YARRA CITY COUNCIL

Internal Development Approvals Committee

1.1 66 Cecil Street, Fitzroy - PLN17/0398 - Full demolition of the existing building, and development of the land for the construction of three dwellings.

1. This report provides Council with an assessment of a planning permit application submitted 66 Cecil Street, Fitzroy. The report recommends approval of the application, subject to a number of conditions.

DWG NUMBER TP002 ISSUE -

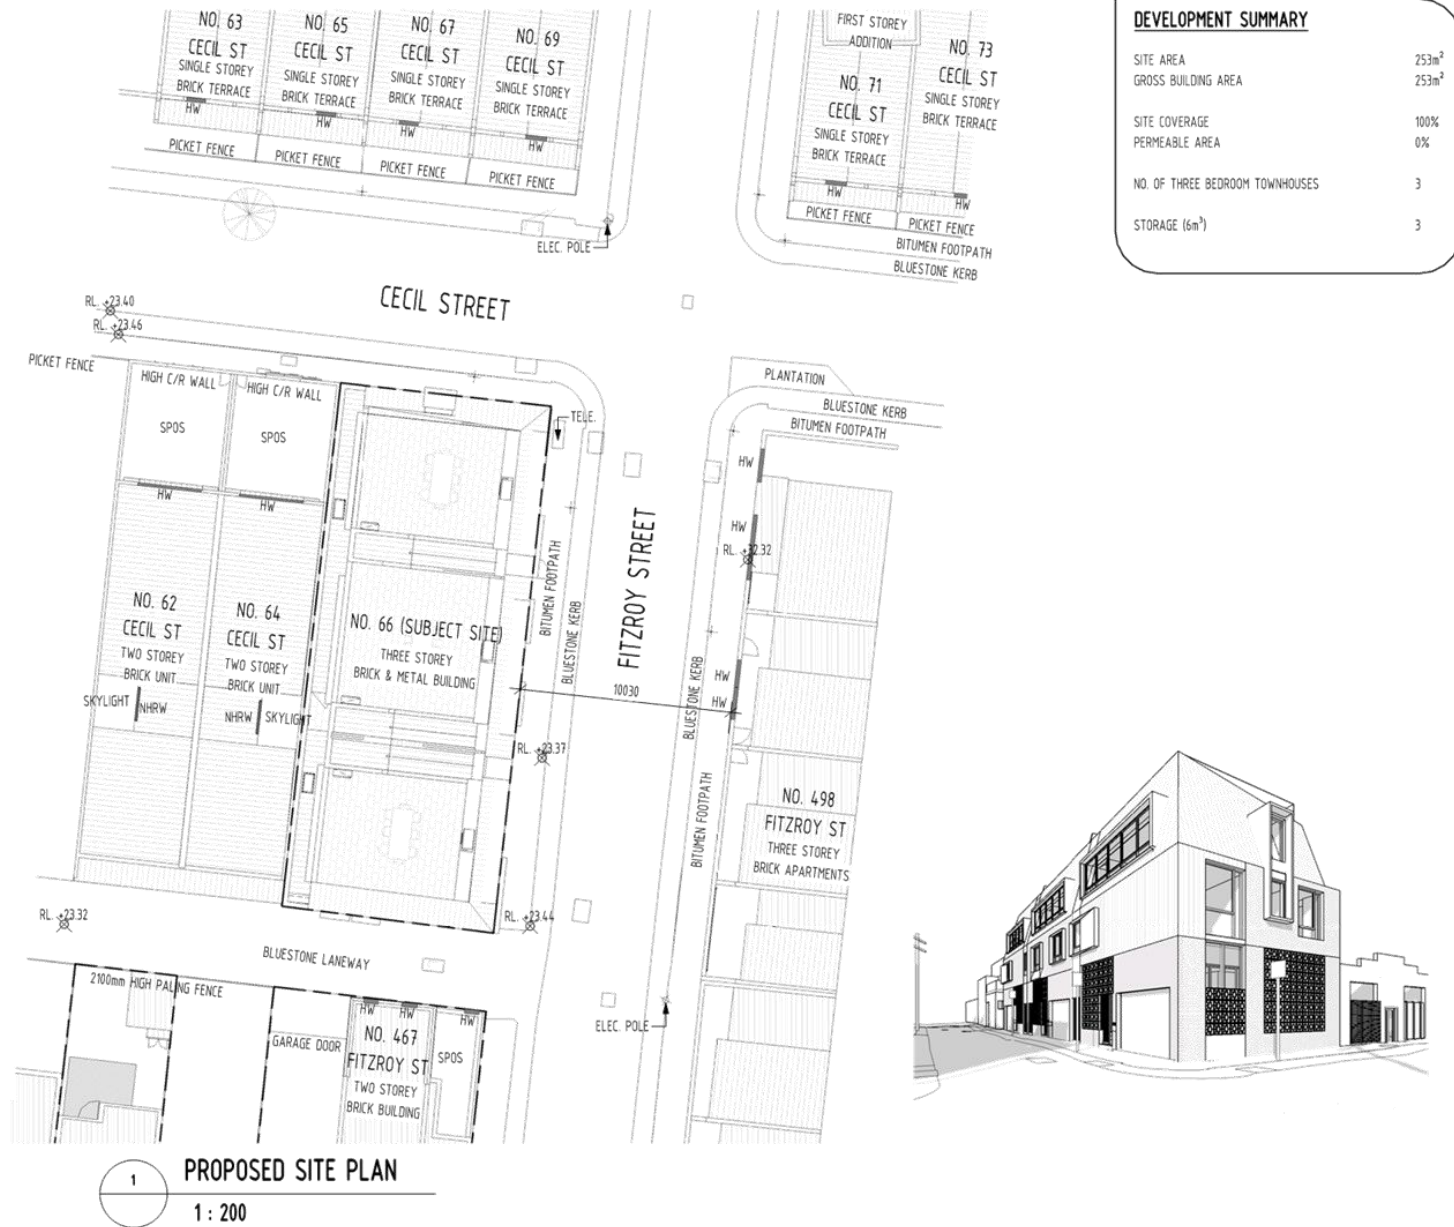
TP002 – DESIGN RESPONSE

1. Reduction in overall height by one level.
2. Reduction in number of townhouses from 4 to 3.
3. Reduction in number of crossovers from 4 to 3.
4. Extent of brickwork, metal cladding and window configuration has been amended to suit the modified design

Above: Line of transitional height shown in red. Preferred maximum height of development shaded in blue.

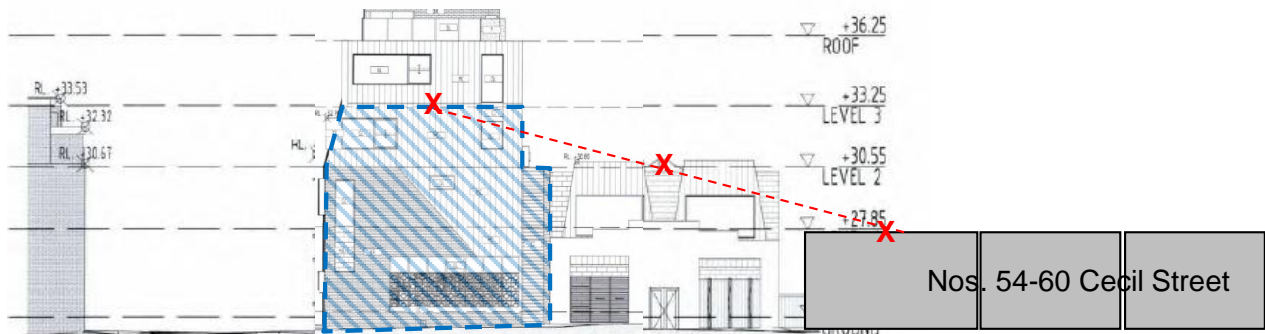
Although the proposed Levels 2, 3 and the roof terraces of the new development are slightly set back, the building will still clearly read as an almost sheer perimeter wall of about 13 metres in height. Being a corner site means that these 13 metre walls will be fully exposed to two street frontages as well as being visible from all four approaches towards the intersection. Within the Cecil Street streetscape, the height of the proposed façade will be twice as tall as the immediately adjoining townhouses (nos. 62 and 64) and will be a dramatic contrast in scale to the nearby single-storey dwellings of contributory significance.

Using the finished height of nos. 62 and 64 for a mid-way transitional purposes, it is considered that the maximum height of the proposed development fronting Cecil Street should be no greater than three storeys (or about 10 metres), with the uppermost floor level clearly setback from the street façade. With a reduced finished RL level of about 33.5, the scale of the proposed building will be in keeping with the established height of no. 494 Fitzroy Street.
